In response to your request dated January 15, 1976, the Commission has issued the enclosed Amendment No. 18 to Facility Operating License No. DPR-35 for the Pilgrim Nuclear Power Station Unit No. 1.

PILGRIM NUCLEAR POWER STATION UNIT NO. 1

Amendment No. 18  
License No. DPR-35

ATTACHMENT TO LICENSE AMENDMENT NO. 18

Figure 6.2.1  
 Boston Edison Company — Organization for Operation  
 of Pilgrim I

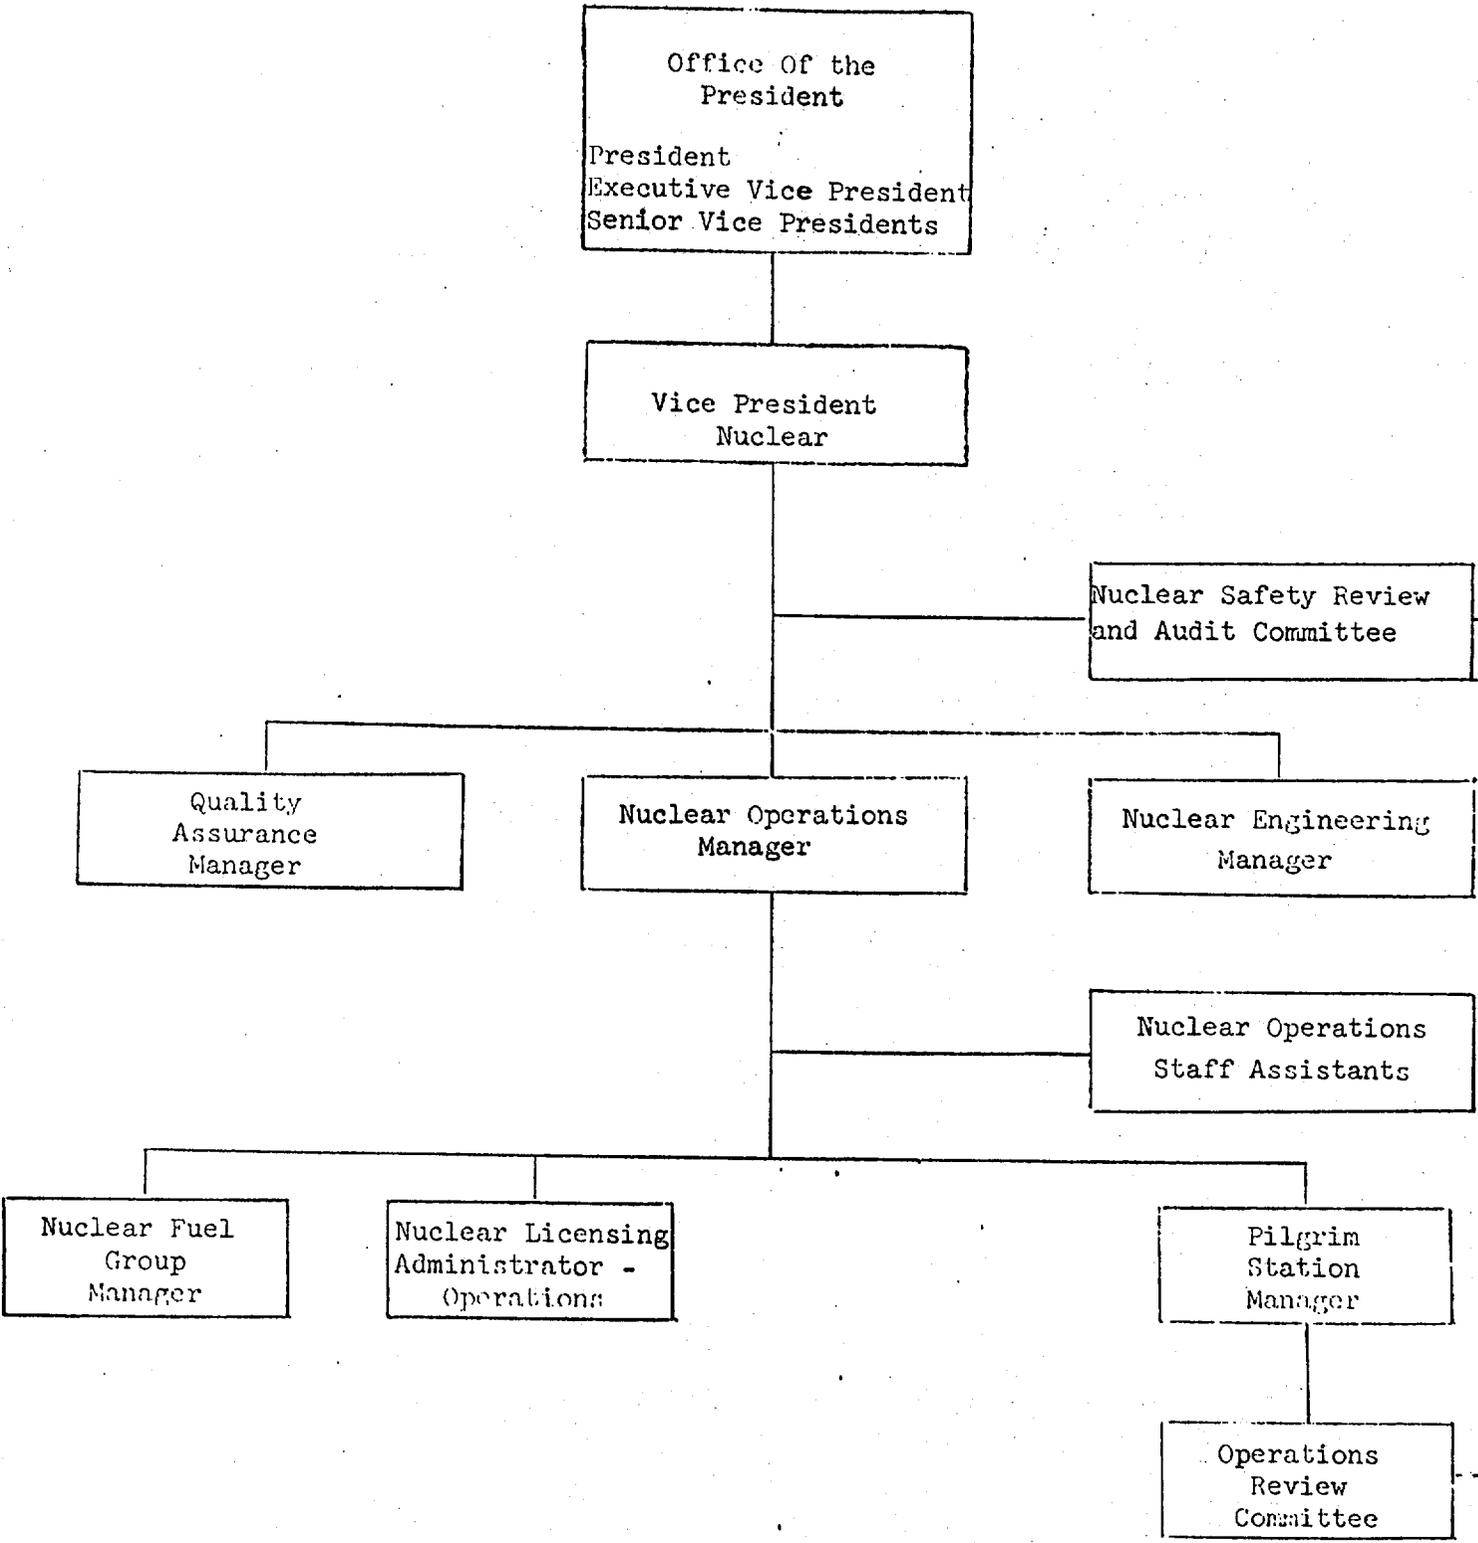
This amendment changes Figures 6.2.1 and 6.2.2 of the Technical Specifications which describe the Boston Edison corporate organization and the Pilgrim Station organization, respectively. The change also adds a requirement to report changes in corporate and station organization to the NRC within 30 days.

1. Reflect a change in the Boston Edison corporate structure,
2. Delete the position of Warehouse Keeper,
3. Add the position of Security Supervisor,
4. Change the functional reporting requirements of the Waste Management Coordinator, and
5. Add a requirement to report changes to the Boston Edison corporate organization or the Pilgrim Unit No. 1 Station organization to the NRC within 30 days.

This change eliminates the position of Operating Engineering Group Manager and places responsibility for all engineering for Pilgrim I under the Nuclear Engineering Manager. We have concluded that this change is consistent with our requirements for corporate support of licensed facilities and does not result in any loss of authority or decrease in responsibilities required for the safe operation of the plant. Therefore, we find this change acceptable.

PILGRIM STATION ORGANIZATION  
Figure 6.2.2

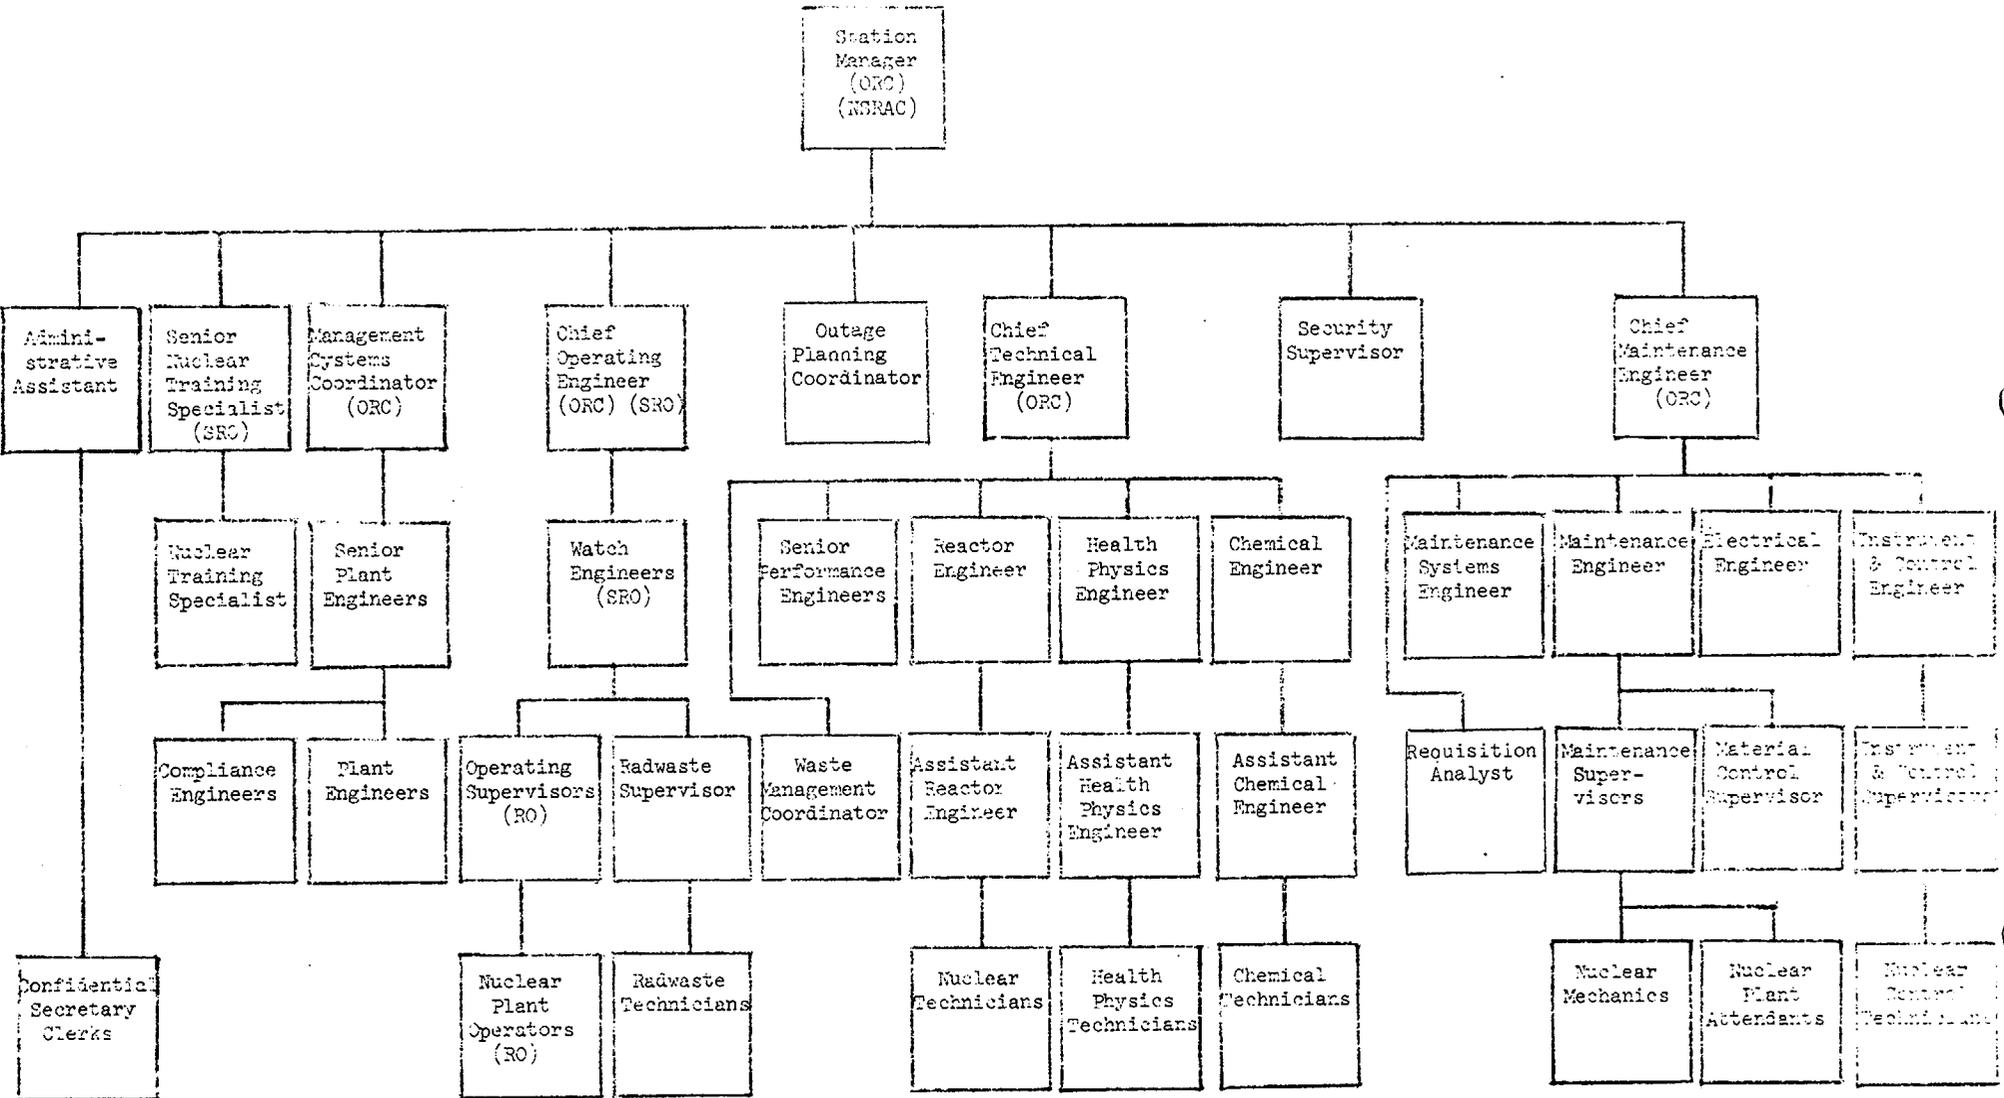
These changes to the Pilgrim Station Organization delete the position of Warehouse Keeper, add the position of Security Supervisor, and change the functional reporting requirements of the Waste Management Coordinator.

The deletion of the position of Warehouse Keeper, who reports to the Material Control Supervisor, should not significantly affect the control of maintenance material at Pilgrim Station since the organizational structure for supervision of material control would remain intact.

The addition of a Security Supervisor, reporting to the Station Manager, should place additional emphasis on security at Pilgrim Station and is acceptable.

The change of functional reporting requirements for the Waste Management Coordinator so that he reports to the Chief Technical Engineer rather than the Chief Operating Engineer should not affect waste management at Pilgrim since the relative position in the organizational structure and the duties of the Waste Management Coordinator would not be affected by this change.

We have concluded that the proposed station organizational structure is consistent with our requirements for nuclear facility staffing and is acceptable.
